2.12 Station Electrical Systems

The information in this section of the reference ABWR DCD, including all subsections, figures and tables, is incorporated by reference with the following departures.

STD DEP T1 2.12-1 (Tables 2.12.1, 2.12.12, 2.12.14 and 2.12.15)

STD DEP T1 2.12-2 (Figure 2.12.15)

Figure 2.12.15 Instrument and Control Power Supply

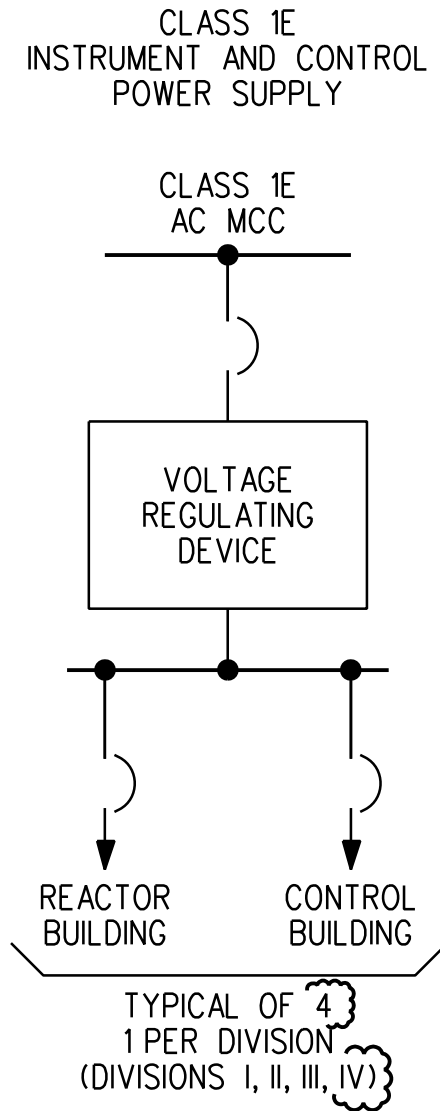
STD DEP T1 2.12-2

The Class 1E Instrument and Control Power Supply consists of ~~three~~ four divisions (Division I, II, ~~and III, and IV~~) of interruptible power supplies with their respective distribution panels. Each Class 1E power supply provides interruptible, regulated AC power to Class 1E circuits which do not require continuity of power during a loss of preferred power (LOPP).
